**Re: Lost Creek Project Responses November and December 2009 Technical Comments
Docket No. 40-9068
TAC No. LU0142**

**RESPONSES TO
NRC REQUESTS FOR
ADDITIONAL INFORMATION**

**December 2009
and
November 2009**

**for the
LOST CREEK PROJECT
Wyoming**

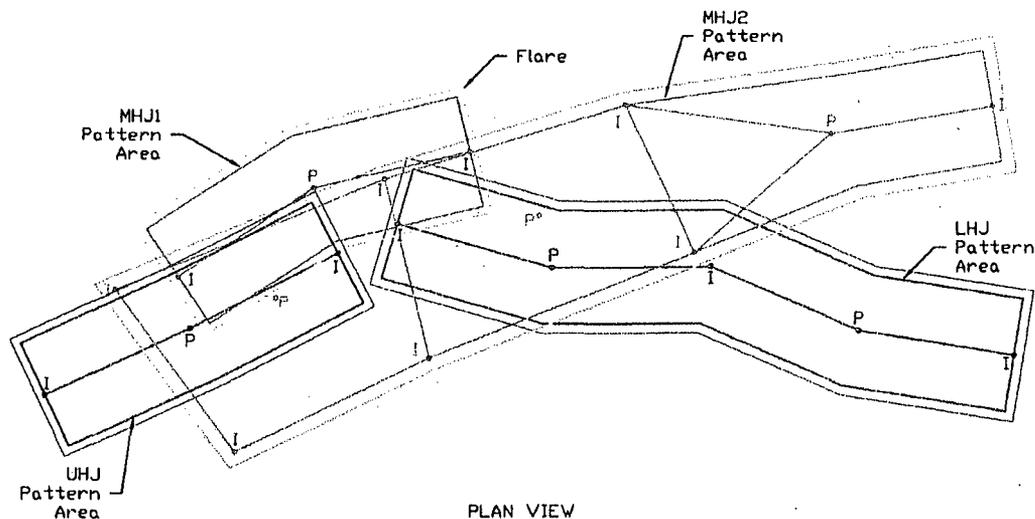
NRC staff needs supporting evidence that the use of average completion thickness in lieu of thickness of the ore sand is appropriate in the pore volume calculation. LCI reports that the thickness of the mineralization varies from 5 to 28 feet, with an average of 16 feet. LCI also indicated that the restoration would only be completed in areas with multiple mineralization zones after production at all zones. If production is done in all zones, it appears the restoration pore volume should account for the thickness of multiple zones (NUREG 1569 6.1.3 (2)).
